International Panel of Experts

Safety of Nenskra Hydropower Project - Georgia

STAGE II REPORT - Part 2 & Final

Date: 27 February 2017

Figure 22 Alignment of TT on geological map (L-6768-B-GS-TT-GE-DW-001_000, dated 15.12.16)

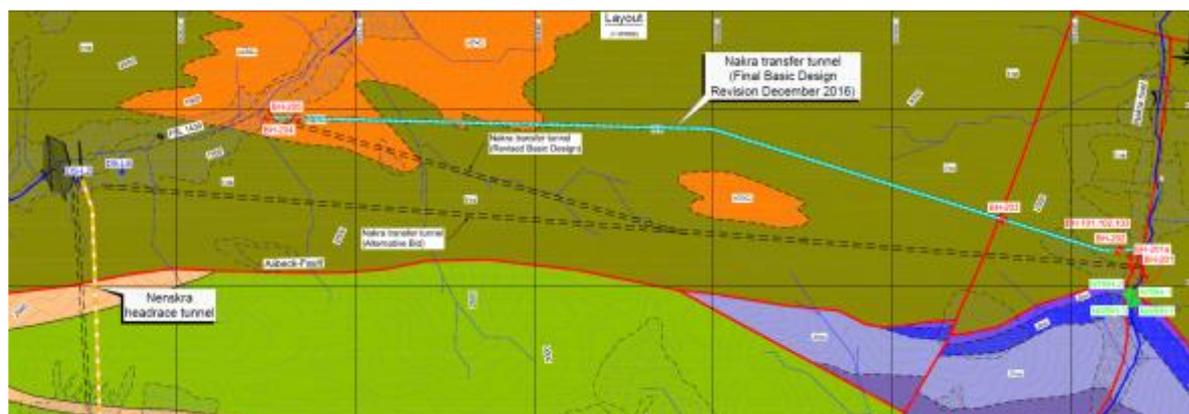
Considering the general layout on the geological map (L-6768-B-GS-TT-GE-DW-001_000 dated 15.12.2016 and Figure 22) the IPOE notes that both Nakra intake and Nenskra outlet have been shifted towards upstream, while the central vertex has been shifted North, both to increase the distance to the fault and to minimize the maximum overburden.

From the geological point of view, the present alignment may be qualified as optimal, keeping in mind that the sub-parallelism of the alignment and the main geological pattern means that deficient rock mass zones, if touched by the tunnel, may still affect it over long distances. But this inconvenience cannot be avoided.

Figure 23 Section of the geological profile on former Transfer Tunnel alignment

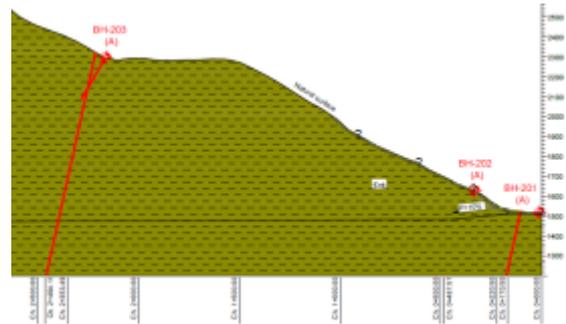
Another comment concerns borehole BH-203 (Figure 23) planned to investigate a fault crossing the tunnel on the side of the Nakra Portal. The opinion of the IPOE is that taking account of the depth of the tunnel such a borehole - as it is drawn on the profile - may well give some useful information on the fault zone. However, in-depth extrapolation of this information over several hundreds of meters is extremely challenging in terms of position, as well as fabric and width, not to talk about hydrogeology. Since it will hardly be possible to drill it to the depth of the tunnel, and even less to be sure to touch the fault close to tunnel elevation. Such type of boreholes will not alleviate the need for investigations during excavation by means of drilling ahead of the TBM when approaching an expected or supposed fault zone.

Figure 25 Section of the geological profile (L-6768-B-GL-HR-GE-DW-002_002, 15.12.16)

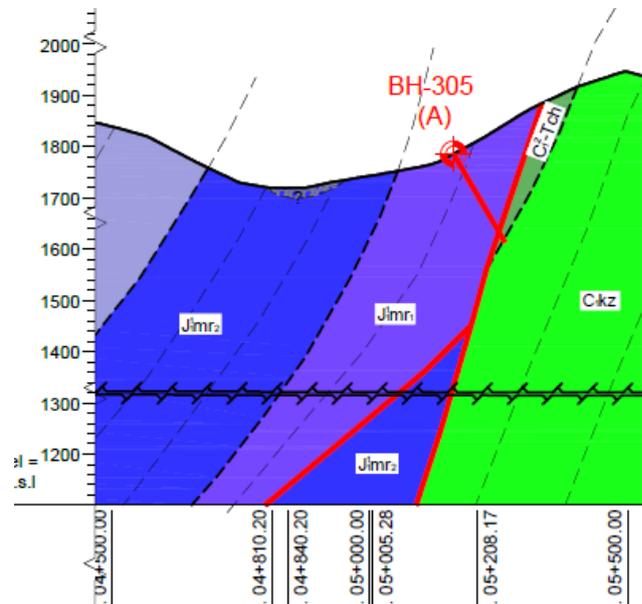
Regarding the future borehole investigations, as for the Transfer Tunnel mentioned above, the IPOE draws attention to the very limited information that can be obtained from "short" boreholes like those drawn on the geological section (even if they are 200-300 m deep), crossing a fault zone hundreds of meters above the tunnel. As already mentioned, in-depth extrapolation of that type of information is extremely challenging, especially where an expected fault zone is supposed to subdivide at depth (Figure 25).

Figure 26 Possible alternative for the Spillway tunnel
(Profile: Bottom Outlet only)

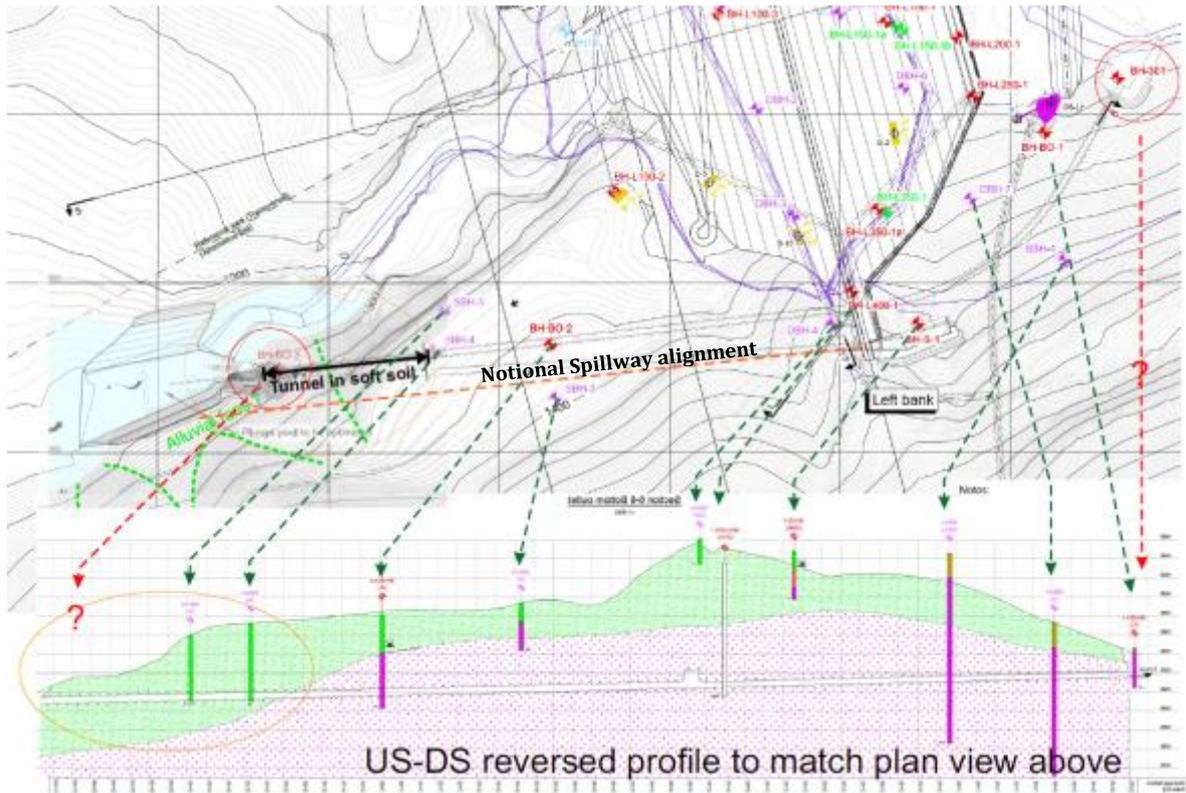
As noted previously it is important that these two tunnels are independent of each other with the Bottom Outlet acting as a back-up for the Spillway under extreme circumstances. These elements, considered from the geological and safety perspective, suggest that the alignment of these two tunnels should be further optimized, based on complementary investigations. It is recognised that for ideal hydraulic performance of the Spillway tunnel it should be straight in plan. The IPOE suggests that

the Spillway tunnel alignment be reviewed to obtain a practical independence of the two tunnels as shown on Figure 26 below.
